# Memorandum

**To:** Lou Kamermans  
**From:** Mike Settingington, R.P.Bio.  
**Date:** July 23, 2019  
**Project No:** 19Y0006  
**Re:** Railway Embankment “Sensitivity” Analysis for Caribou Crossing Potential

**Figure 1.** Flowchart for determining the potential of the Railway or Road embankment to be a physical barrier to caribou movement.

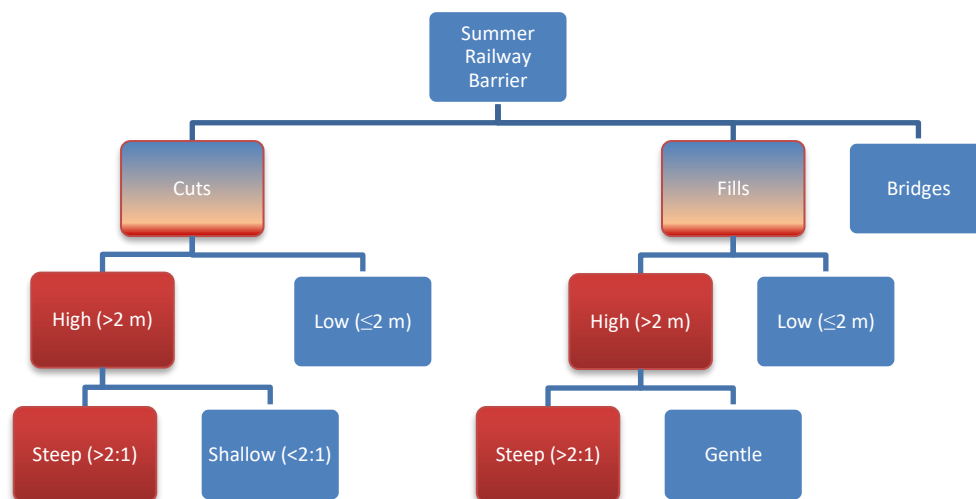
The Government of Nunavut (GN) in technical comment GN-TCR 12 and follow-up specific request from Technical Meeting 1, requested that Baffinland provide a “sensitivity” analysis of the railway embankment as a potential barrier to caribou movement. Specifically, Baffinland was requested to “... *re-analyze the potential impacts to caribou crossing of the railway. This re-analysis will include alternative combined embankment + superstructure + rail heights of  $\leq 1.5$ ,  $\leq 2.0$ , and  $\leq 2.5$  metres, and slope and embankment grain size as potential barriers to caribou movement.*” This request was made to address the uncertainty of the height criteria used for the Approved Southern Rail and Phase 2 Northern Rail presented in Figure 1 of TSD 10 (attached below). Those criteria did not consider grain (material) size. This memo focuses on the alternative analyses of differing embankment height criteria.

- Most of the embankment length is higher than set criteria ( $> 2$  m)
- The initial assessment did not include height of “superstructure”
- The boulder material used as part of Run of Quarry material is likely too large and may entrap caribou legs
- The slope may be too steep along most of alignment (when compared to the 2H:1V ( $< 26^\circ$  slope suggested for mitigation, as is used at Ekati Diamond Mine (e.g., Dominion Diamond 2015)

Using height criteria alternatives from  $\leq 1.5$ ,  $\leq 2$  and  $\leq 2.5$  m, potential permeability in the absence of any other mitigation ranges from 19 to 43% (Table 1). Without further mitigation by design (e.g., flattening slope to anything as gentle or gentler than 2H:1V [ $26^\circ$  slope], filling larger rock voids with finer material) up to 43% of the northern rail may be suited for caribou crossing. As a conservative approach (i.e., overestimating a potential negative effect), we are assuming that none of the cut sections are permeable, but approximately 50% (of 17.7 km) of cuts will be at a slope of 2H:1V ranging in depth from 0–10 metres.
